ADDENDUM NO. 3

DATE OF ISSUANCE:	April 25, 2024
PROJECT:	2024 Addition and Renovations North Harrison Elementary School 1115 W. Whiskey Run Road Ramsey, IN 47166
OWNER:	North Harrison Community Schools
ARCHITECT'S PROJECT NO.:	23-228.001
ORIGINAL BID ISSUE DATE:	April 03, 2024

2
C501

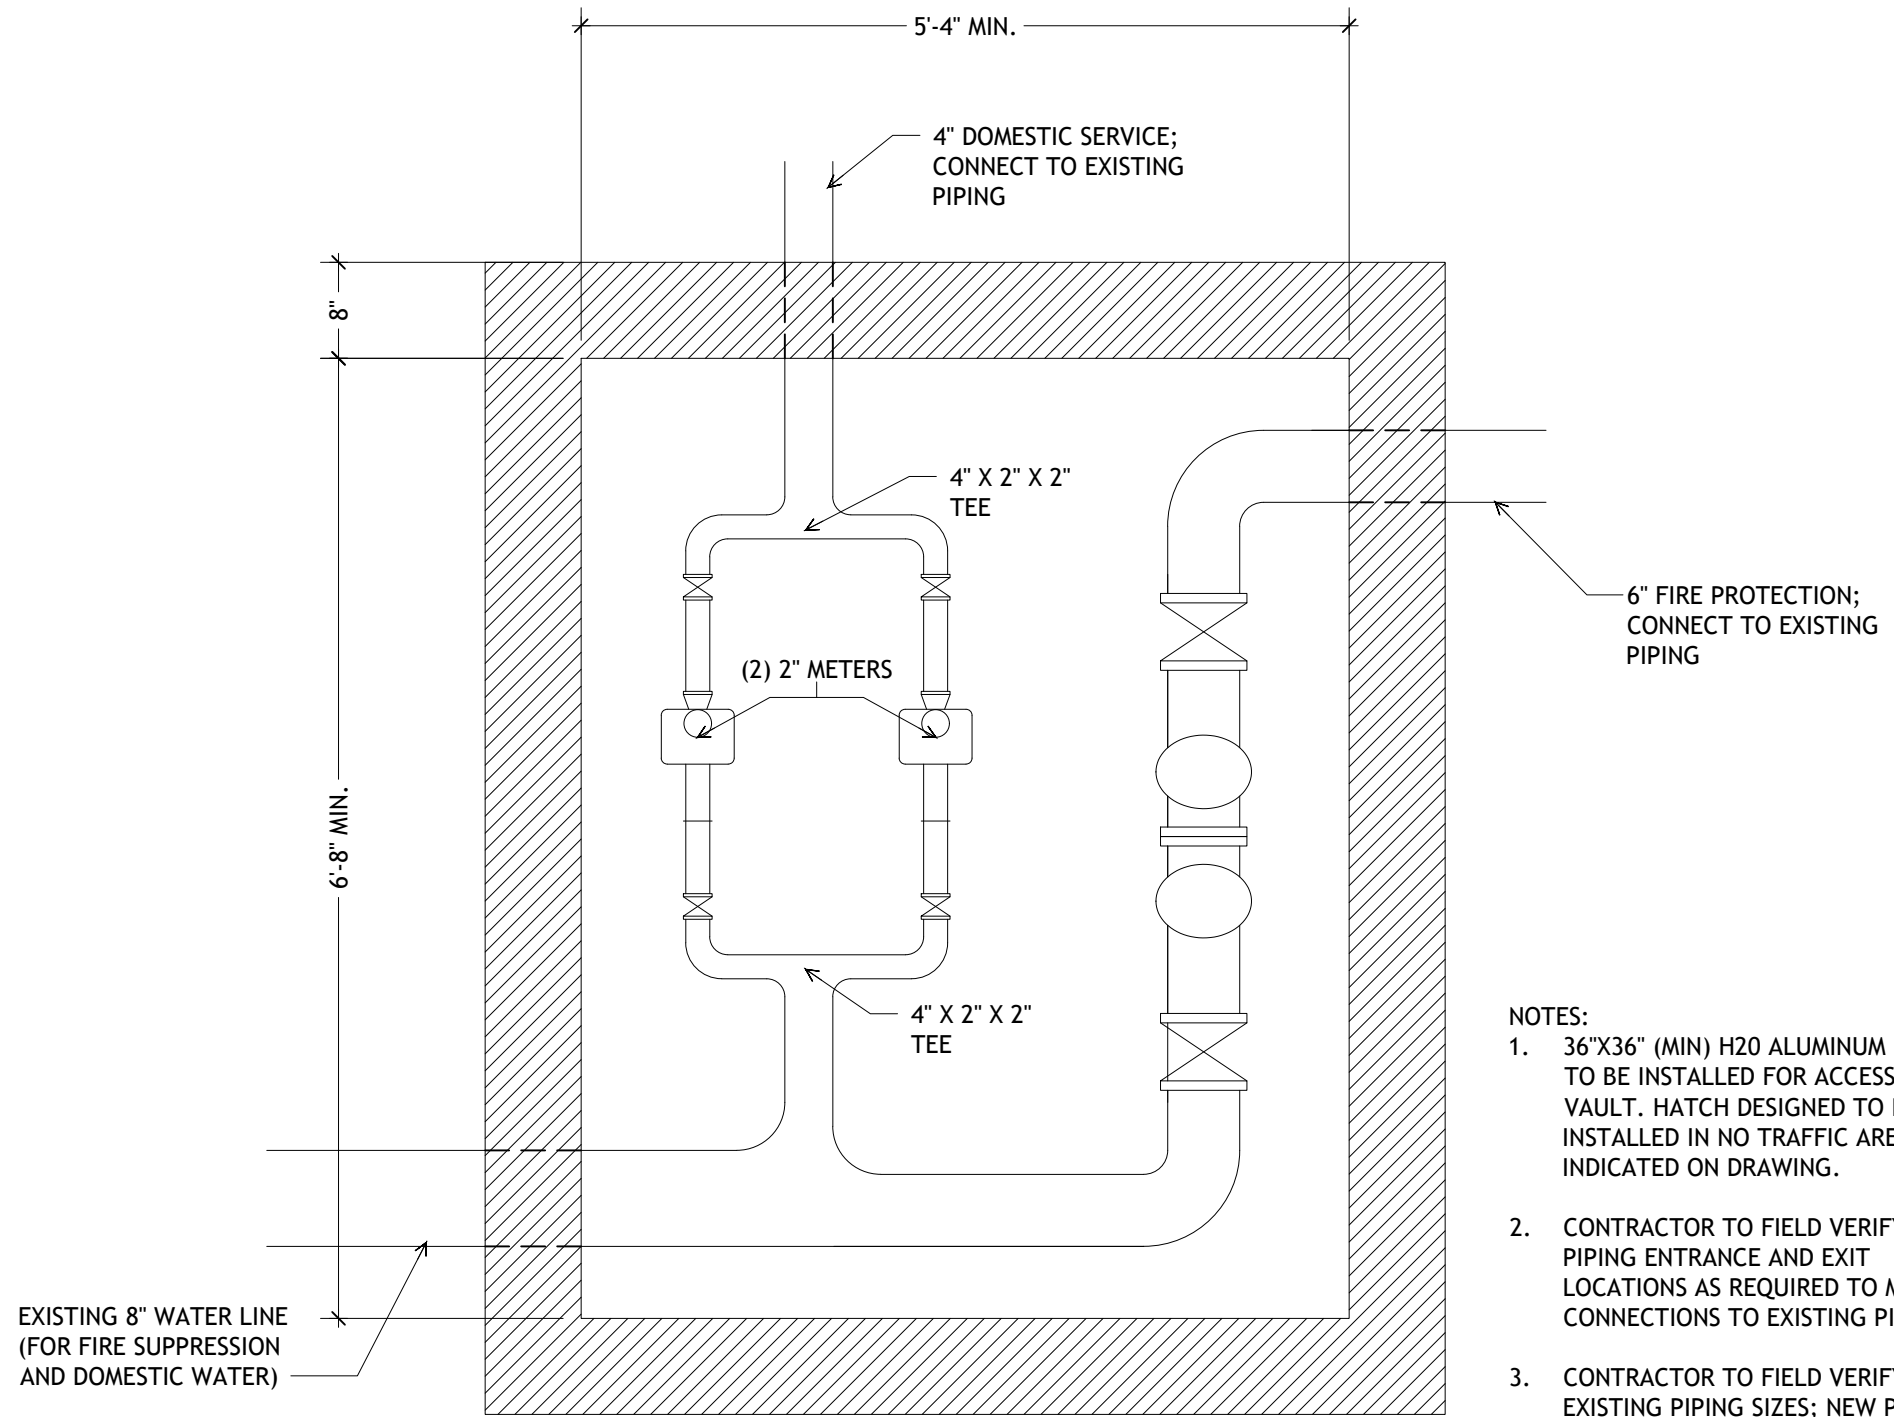
ADD-3 Item No. D-1 - Water Service Vault

Refer to Sheet(s): C501

Add attached Drawing AD-3B which includes a revised detail of the water service vault plan view.
